December 10, 2019

**Addendum No. 01
TO THE CONTRACT DOCUMENTS FOR:**

MANSFIELD FIRE STATION NO. 4

KAI Project No. 2016.166

FLOOR PLAN - MEZZANINE LEVEL

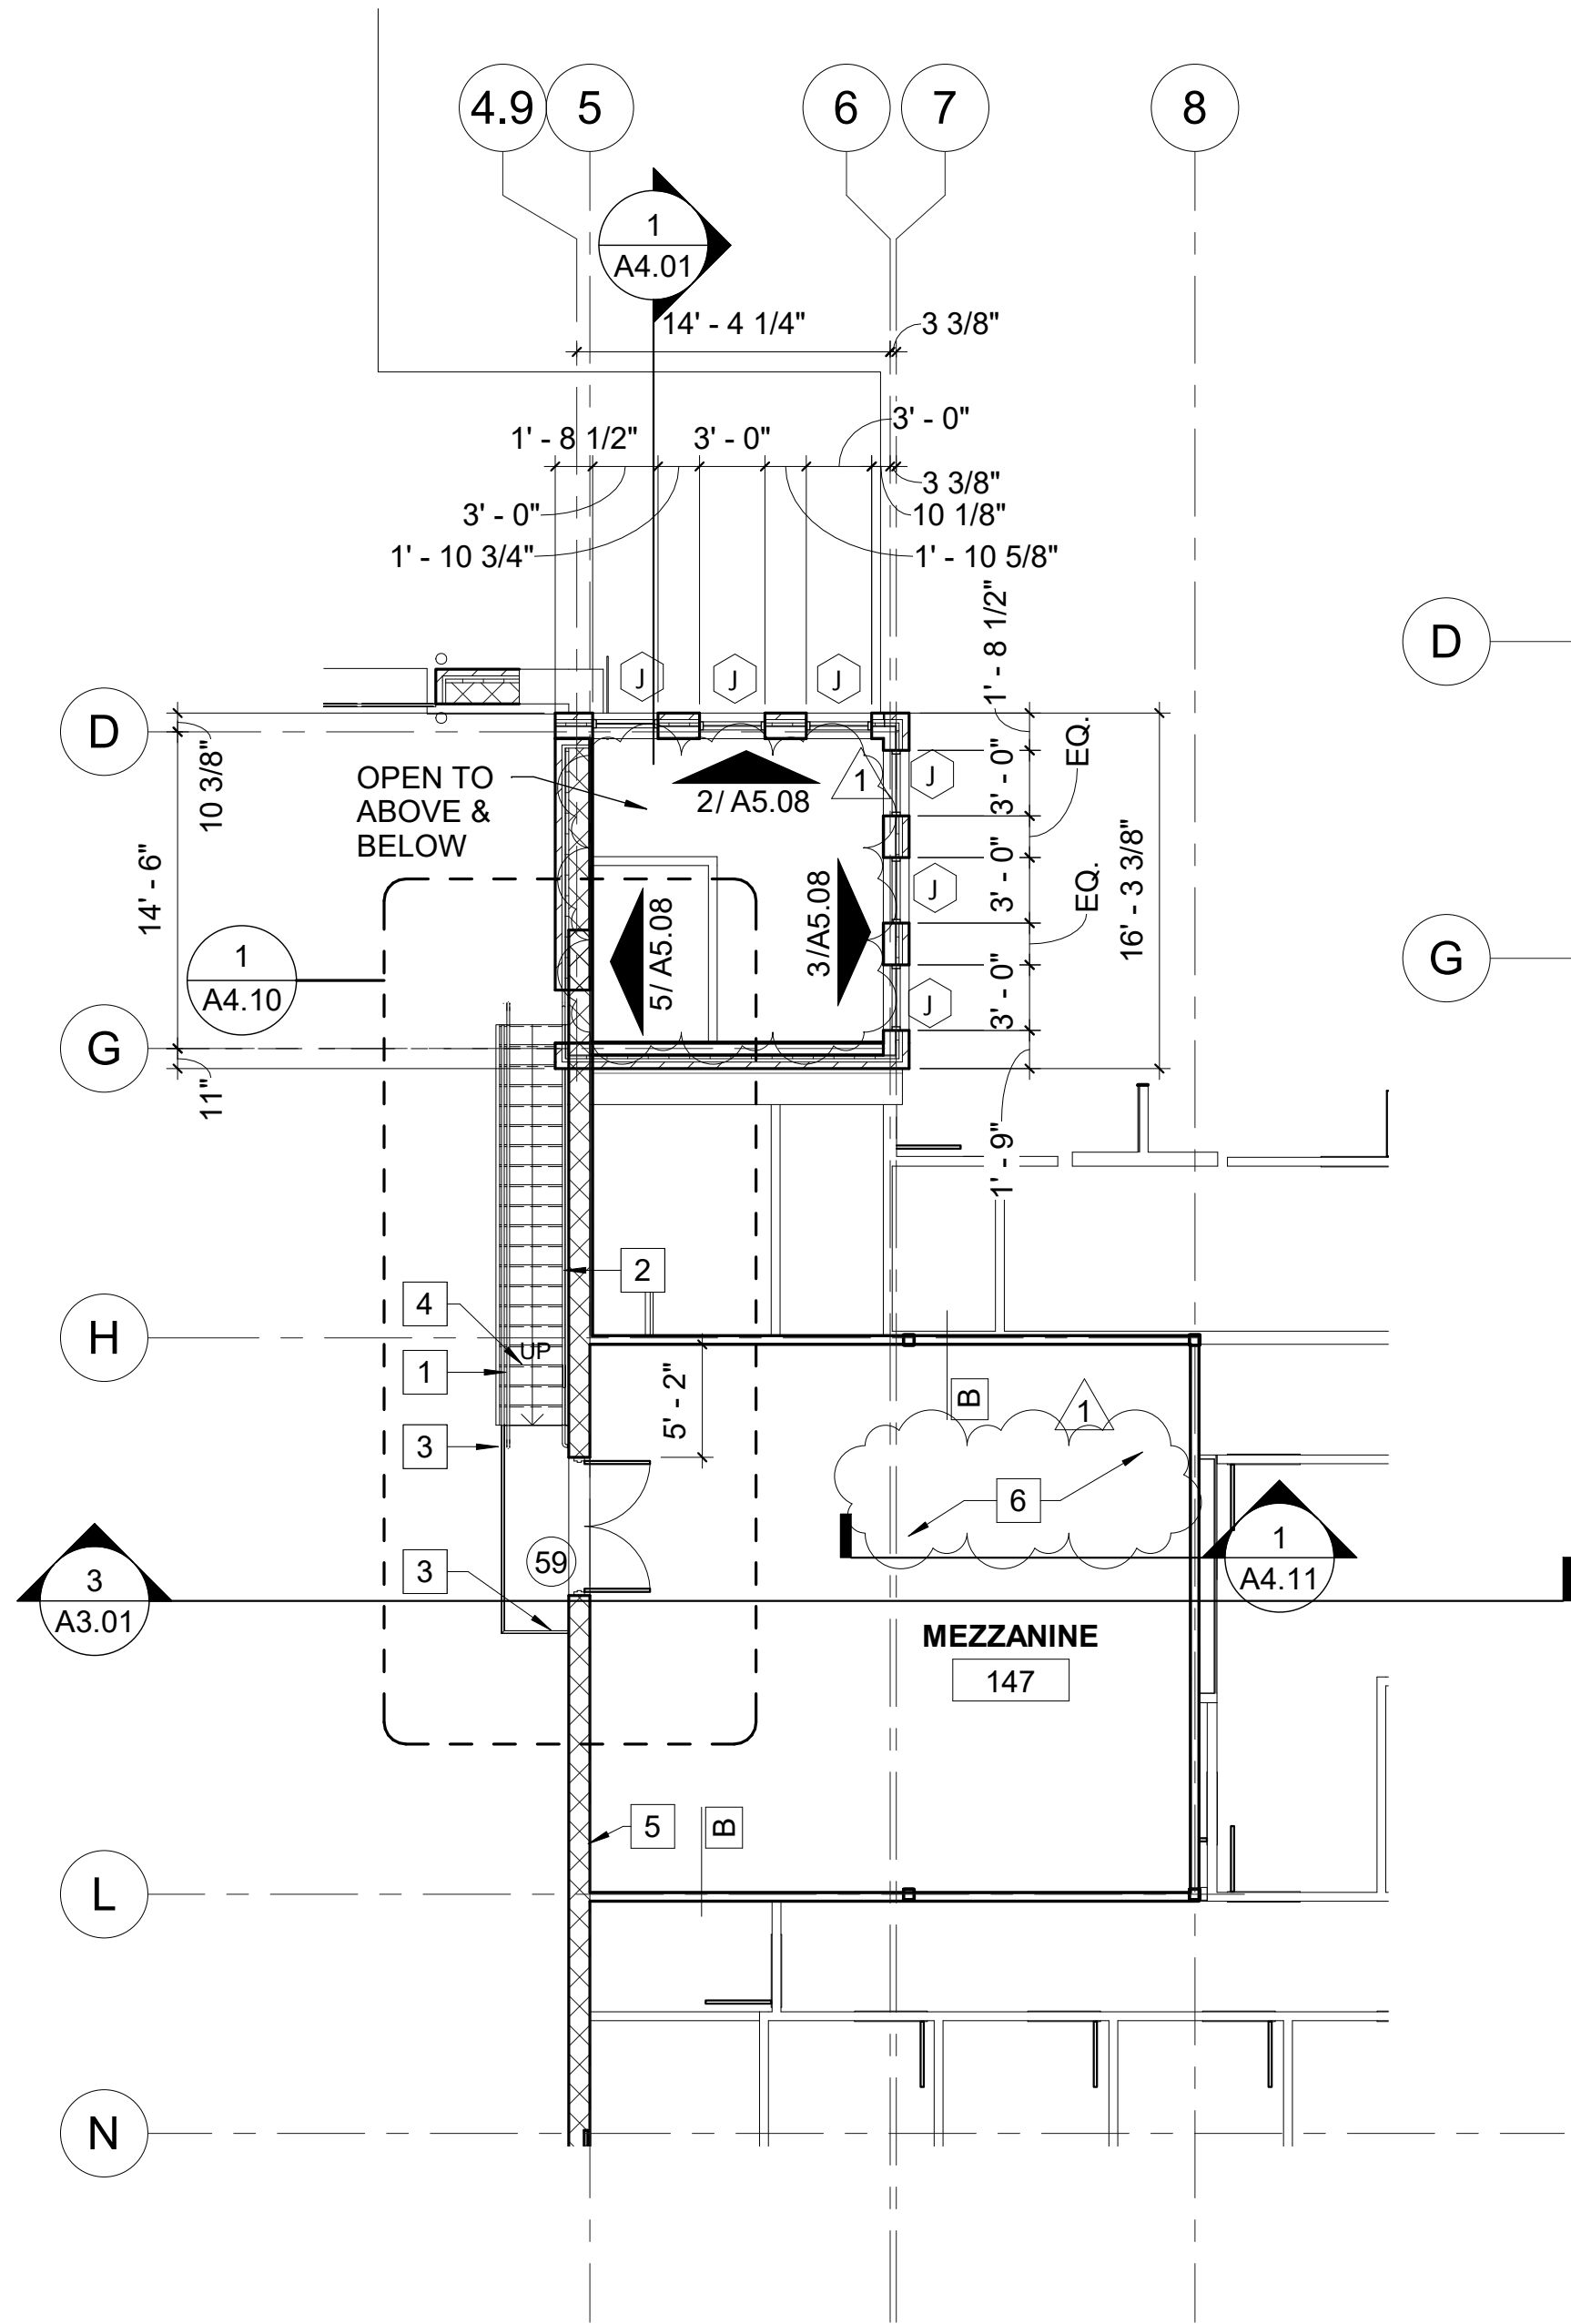
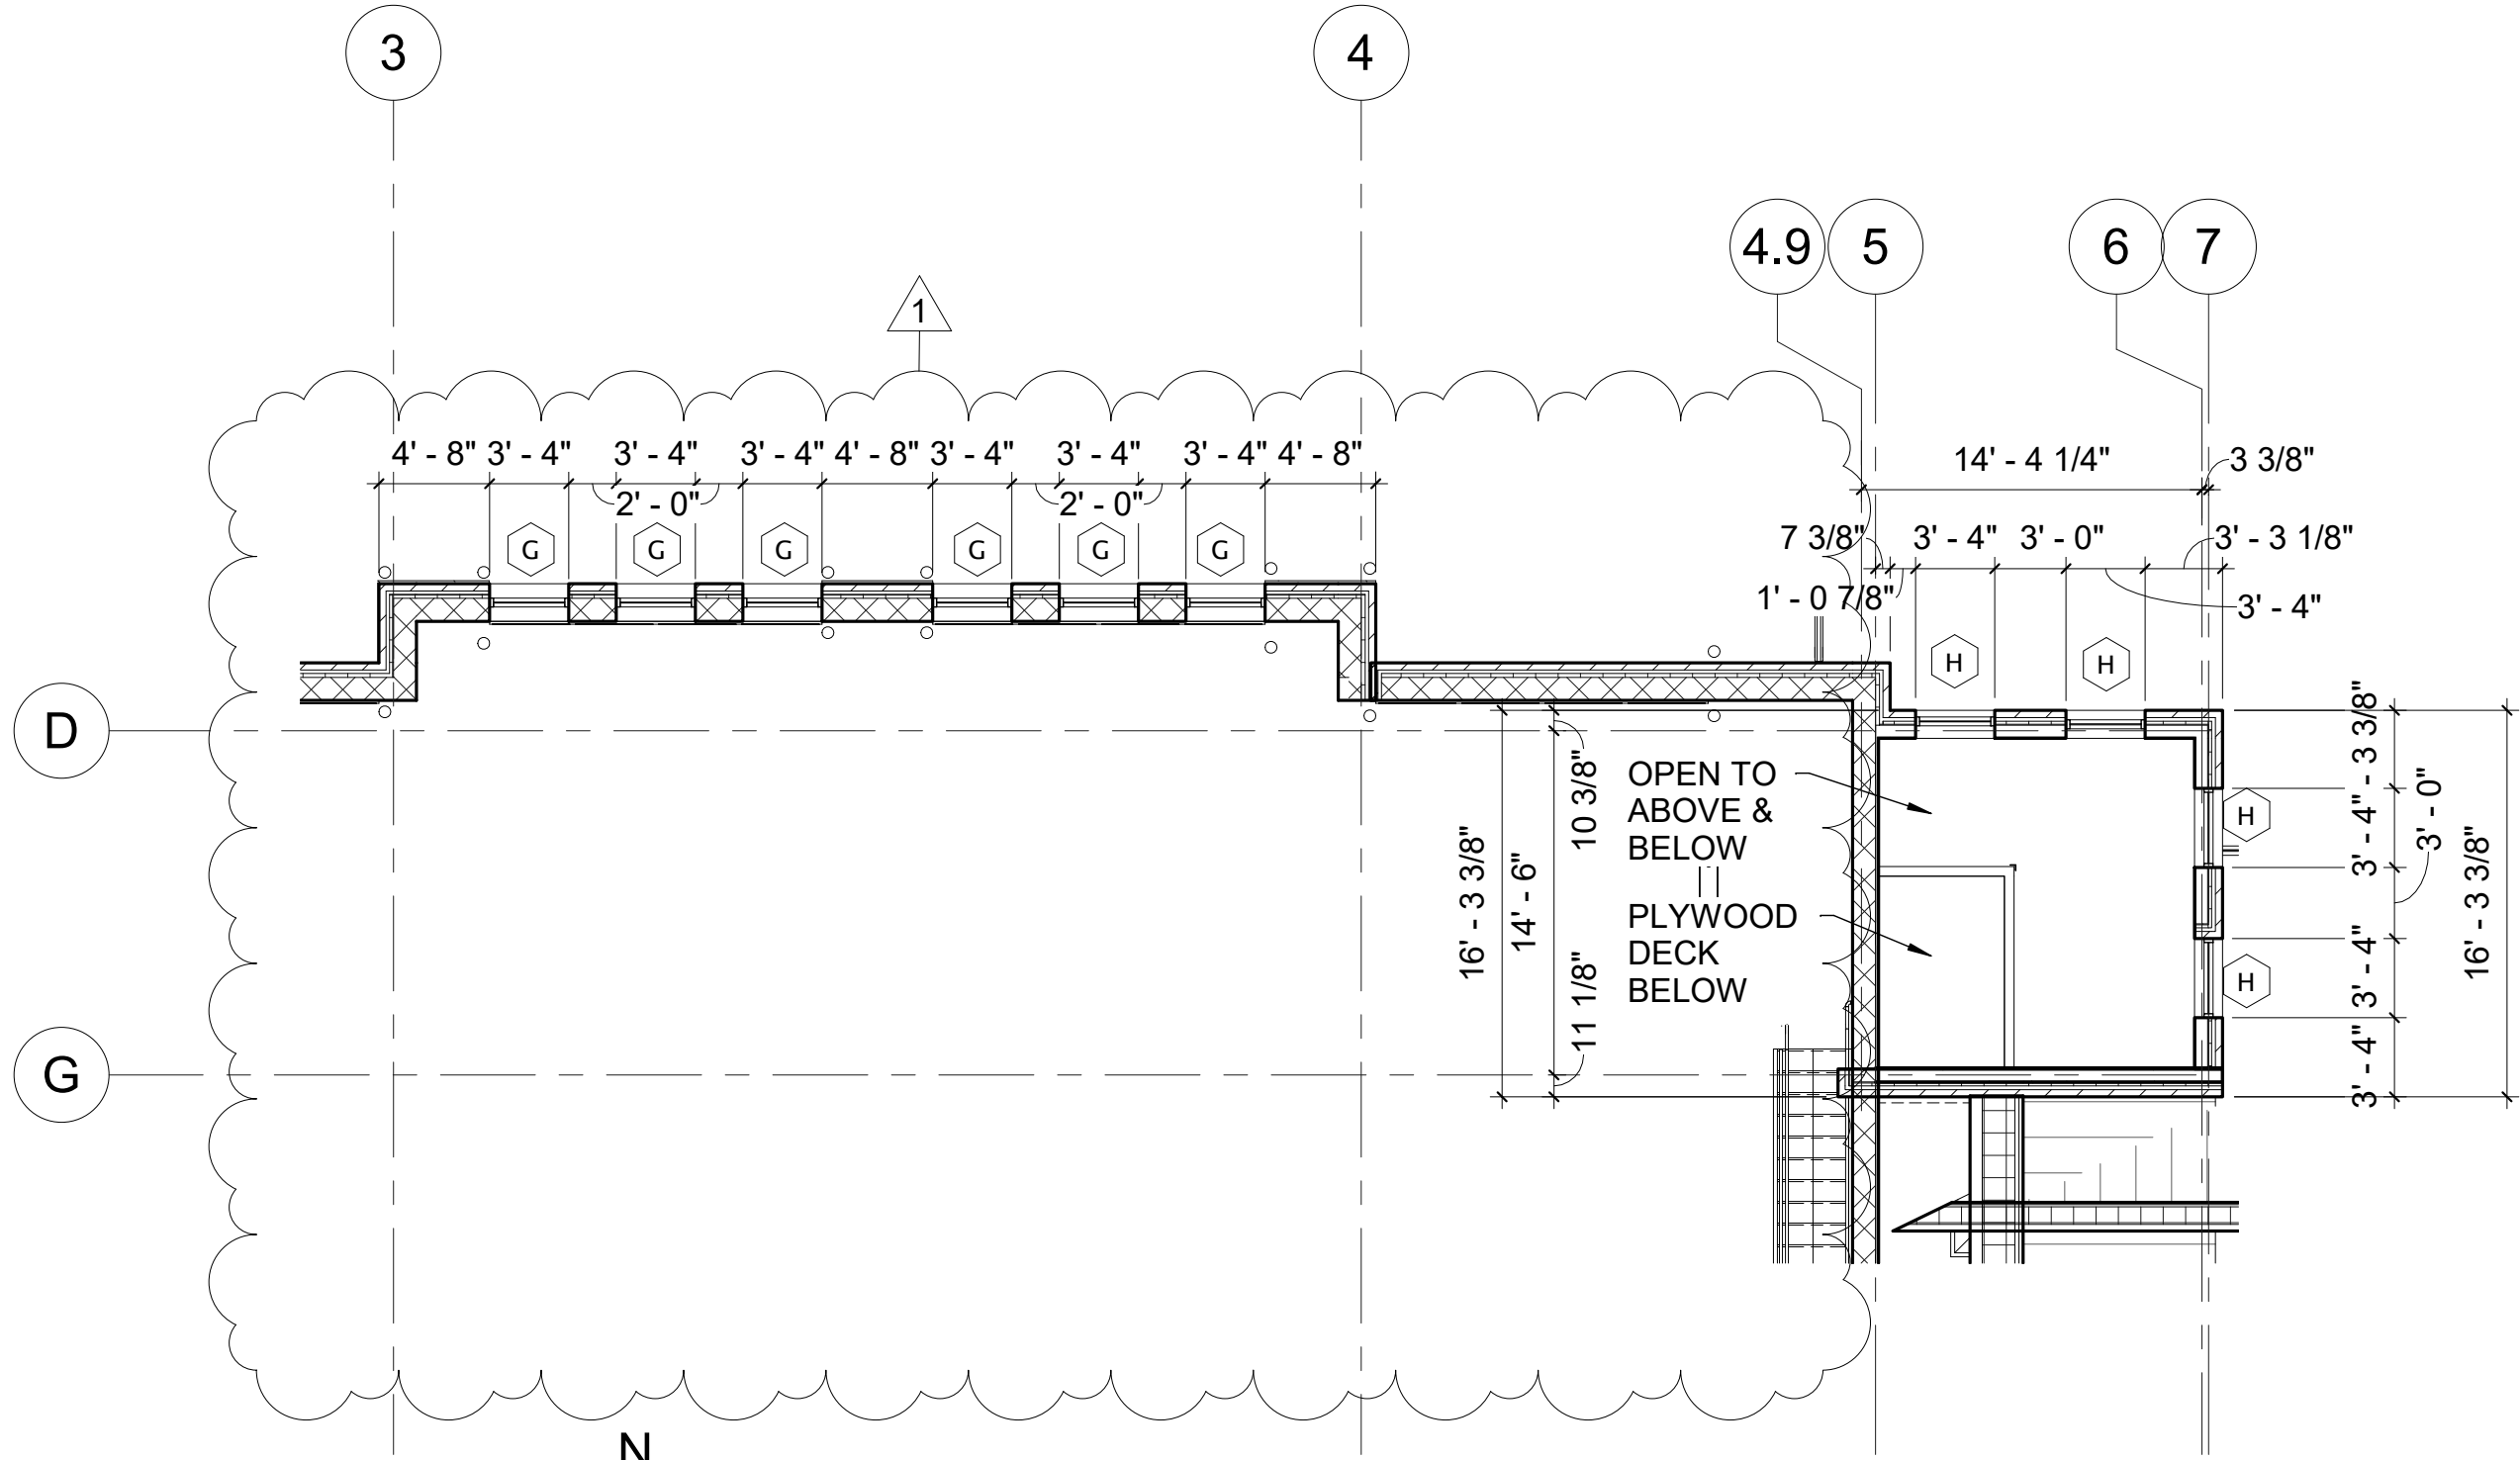
11. Sheet A1.02 – Clarification:
 - a. Add Numbered Note 6: Function of Mezzanine 147 is to be an equipment mezzanine for mechanical, electrical, plumbing and technology equipment

- b. Revised plan 2 to show window type G.
12. Sheet A2.01/A2.02 –
 - a. FINISH LEGEND F-5 Tubelight Slate Gray to be Clear Anodized. Added F-8 – PPG RAL 3011 BROWN RED.
